MDP #804A
411.99 TOTAL ACRES
THIS MDP WAS REVISED ON MARCH 1st, 2007

MASTER DEVELOPMENT PLAN for SOLANA RIDGE SUBDIVISION

Re: **Solana Ridge (Amended)** **MDP # 804-A**

The City Staff Planning Review Committee has reviewed Solana Ridge Master Development Plan **MDP # 804-A**. Please find enclosed a signed copy for your files. Your plan was accepted, however please note the following:

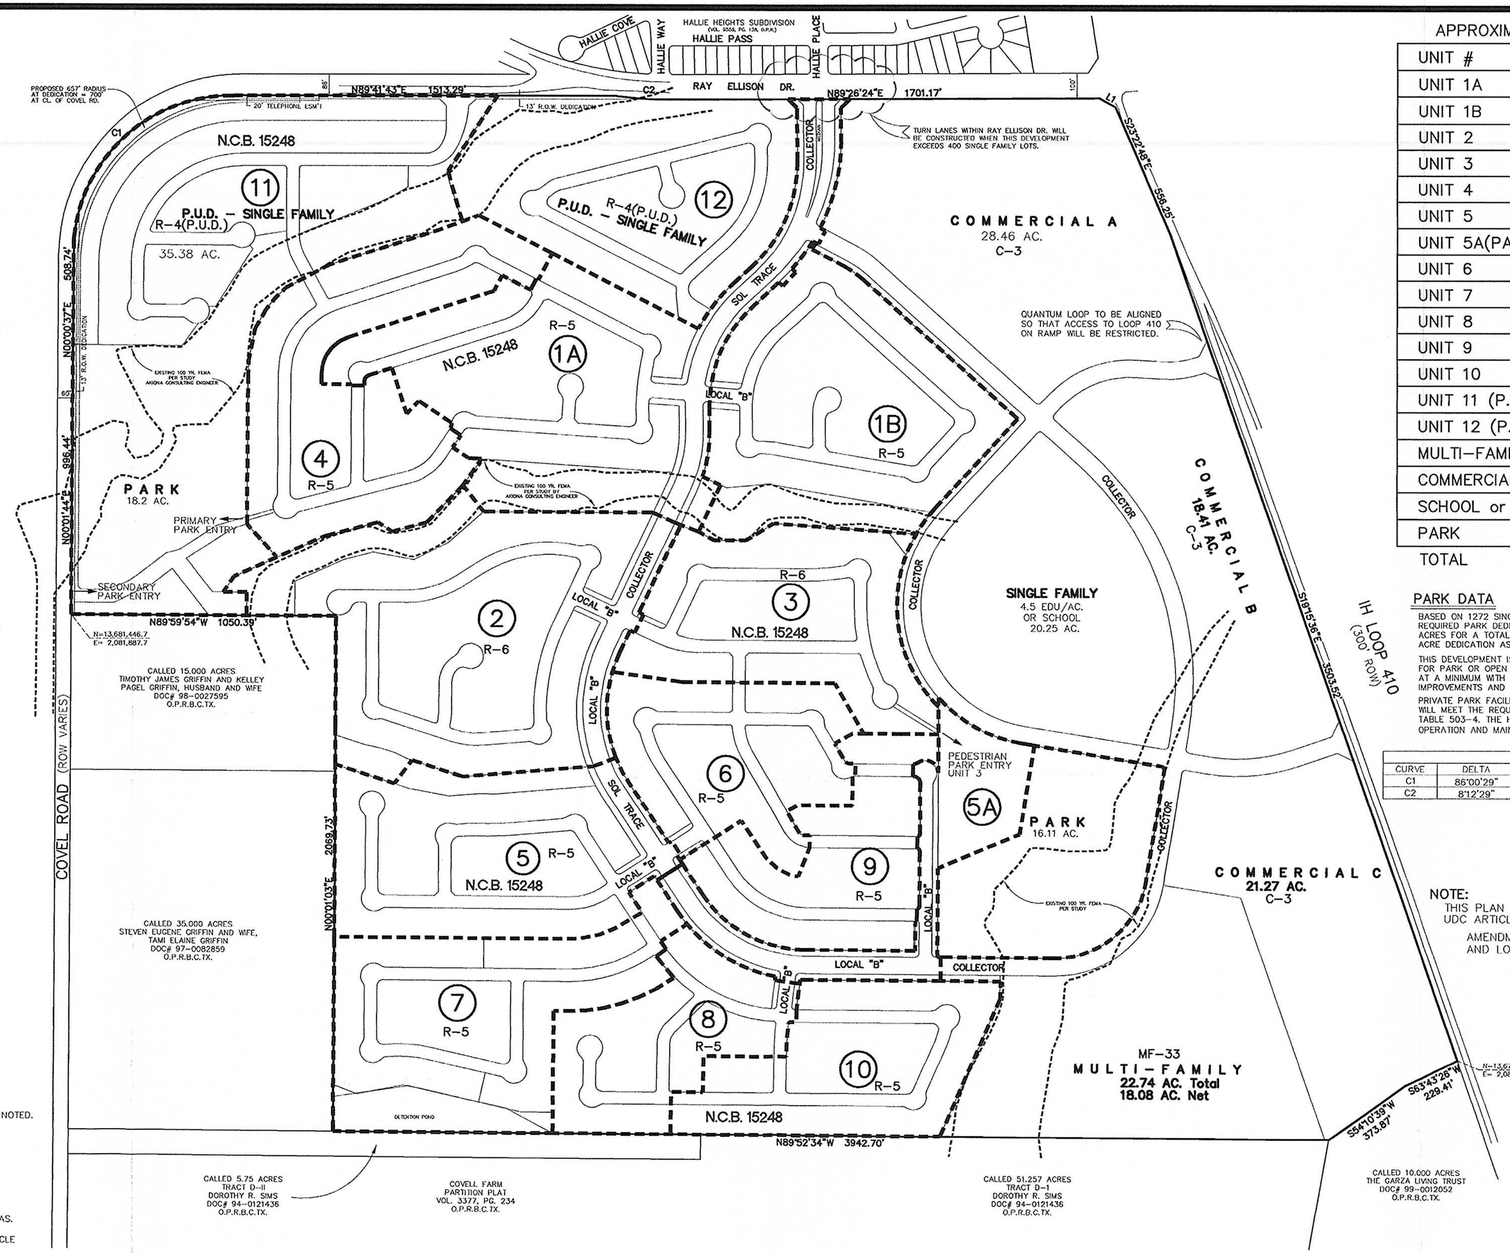
In consideration of public safety and convenience, excessive grades by reason of topography should be avoided in street layouts and arrangements.

The acceptance of this **Master Development Plan # 804-A** is confined to the boundary limits of the site. Any projection(s) of future roadways outside the boundaries does not infer any set alignment of future roadways. All major arterials and streets shall follow all regulations. It will be expected that you will plat all of the property depicted in your Master Development Plan (MDP), to include floodplains, drainage areas and open space.

D.S.D. TIA / Streets Division has reviewed the Level-3 Traffic Impact Analysis (TIA) for the Solana Ridge Master Development Plan (MDP). The analysis is in compliance with TIA Ordinance 91700.

1. Ray Ellison Drive - The Developer shall dedicate 43 feet of ROW (Ordinance 98282, October 2, 2003 Major Thoroughfare Plan (MTP)) from the centerline of Ray Ellison Drive (Secondary Arterial Type A – Uniform Development Code (UDC) 35-506, (g), (2)) adjacent to this proposed project. The total length of property frontage is approximately 2200-feet.

2. Covel Road - The Developer shall dedicate 43 feet of ROW (Ordinance 98282, October 2, 2003 Major Thoroughfare Plan (MTP)) from the centerline of Covel Road (Secondary Arterial Type A – Uniform Development Code (UDC) 35-506, (g), (2)) adjacent to this proposed project. The total length of property frontage is approximately 3700-feet.

3. Construction of an internal collector street system. Collector street design parameters consist of 70-feet of ROW and 44-feet of pavement (Table 506-3). The proposed collector street system shall have no houses fronting (UDC 35-515, (c), (4)).

4. Construction of an internal Local "B" system. Local "B" design parameters consist of 60-feet of ROW and 40-feet of pavement (Table 506-3). The proposed Local "B" system shall have no houses fronting as shown in the submitted MDP.

6. The developer shall be responsible for upgrading the intersection of Ray Ellison Drive and the Collector Street. This includes a sufficient left-turn storage lane on westbound Ray Ellison Drive, with a bay taper and transition (UDC - 35-506, (m), (2) and a right-turn deceleration lane (eastbound Ray Ellison Drive) with a storage lane and bay taper as it relates to the submitted TIA traffic counts, (UDC - 35-502 (a)(7), subsection C. Design and construction shall be coordinated with Development Services TIA Division.

8. All access driveways/roadways shall provide clear sight distance along Ray Ellison Drive, Covel Road and Loop 410 Frontage Road in order to provide adequate obstruction free viewing distances for approaching traffic. All signage, landscaping, and improvements shall be selected and located so as to not block these clear sight distance areas.

- Solana Ridge is a proposed subdivision of 1872 residential units. UDC Section 35-503 requires 1 acre of parkland for every 114 residential units. Solana Ridge has a park dedication requirement of 16 acres of parkland.

- The subdivision will provide two distinct parks. Park "A" (18.2 ac.) located in the northwest quadrant of the subdivision and Park "B" (16.11) in the southeast quadrant. The development of the proposed parkland must be consistent with the schedule set forth in UDC 35-503(g). Failure to provide parkland in the proper timeframe will result in the delay of plat approvals.
